Subject: Pipe Support Review Questions
Comanche Peak Steam Electric Station
Independent Assessment Program - Phase 4
Job No. 84056

PIPE SUPPORT QUESTIONS

MS-1-03-007-C72K
SKETCH

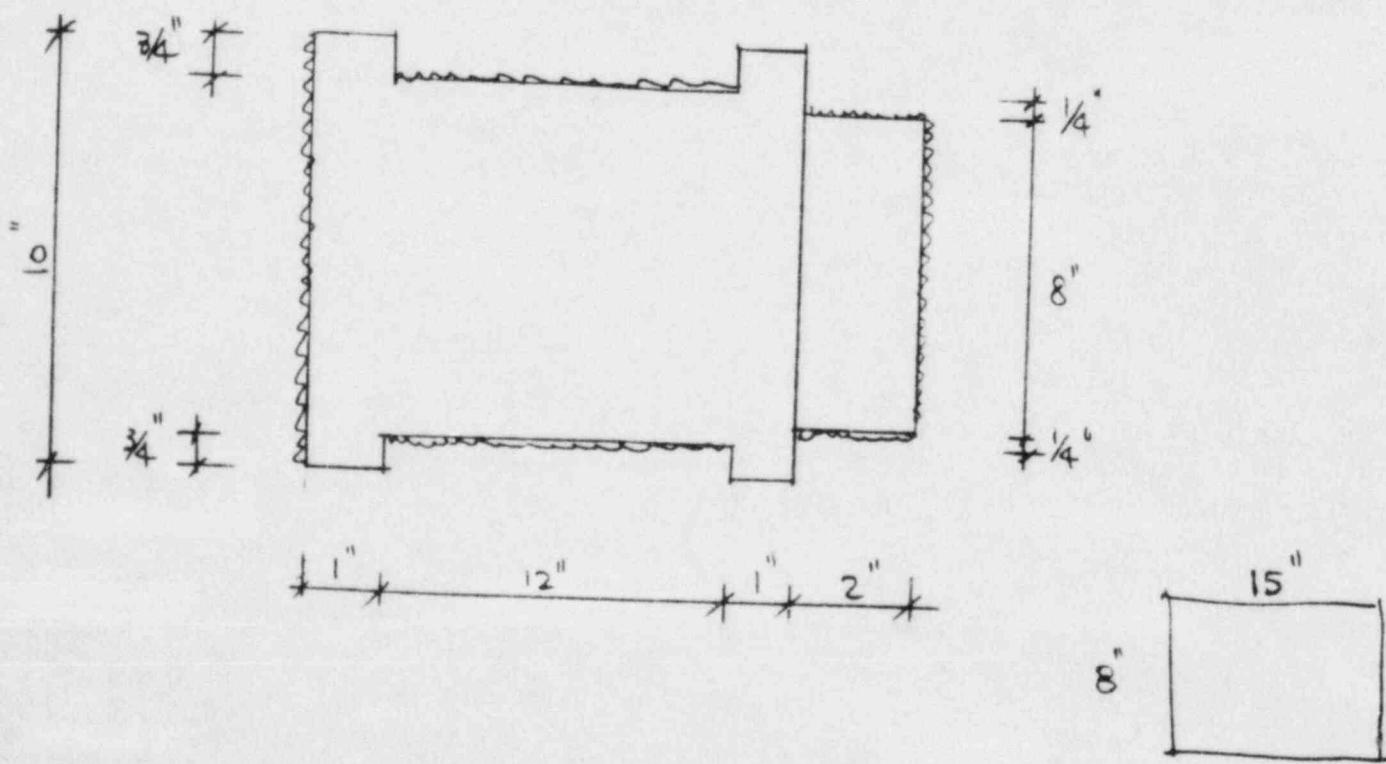
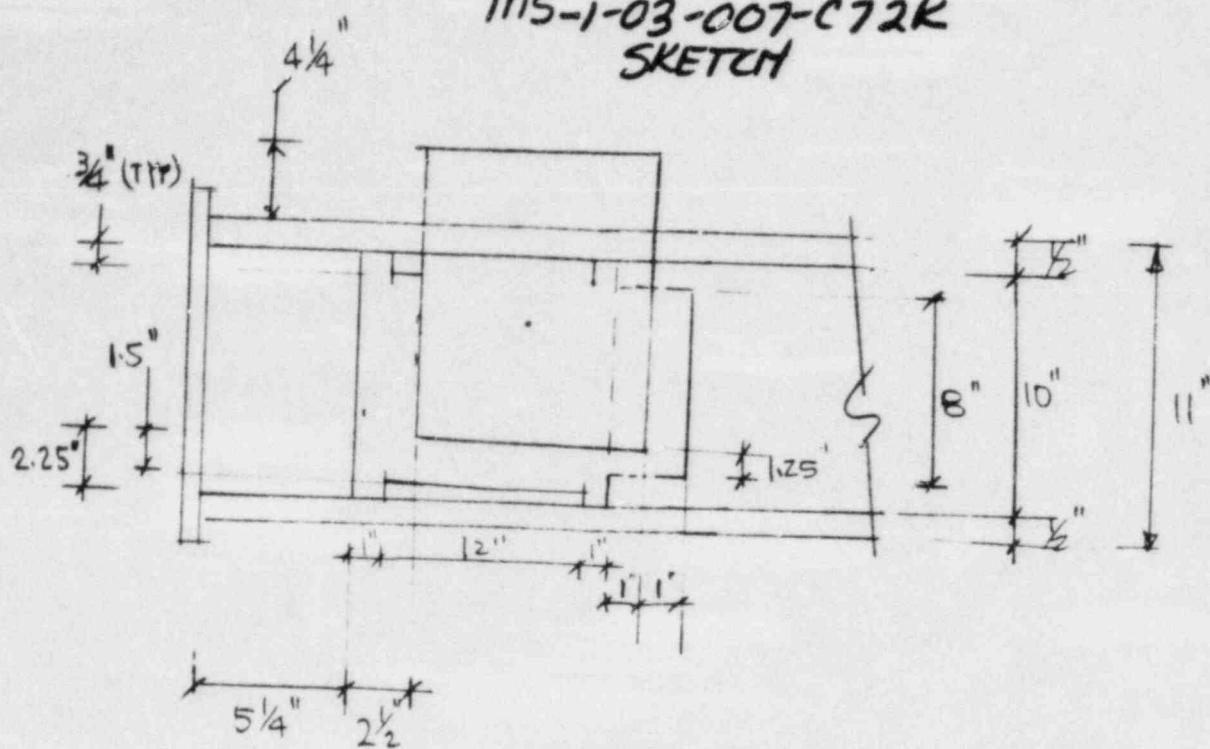
10. MS-1-003-007-C72K, drawing revision 10. In the original review of support MS-1-003-007-C72K, Cygna did not find sufficient dimensioning in section J-J detail 46 to determine where the rear bracket was welded to item 35. During the Phase 4 walkdown, Cygna was able to measure the actual dimensions as shown on the attached sketch.
- a) Did the designers size item 35 without dimensions based on assumptions which were not stated?
 - b) Given the as-built data, please provide calculations showing item 35 is adequate to transfer the load from the rear bracket to item 22.
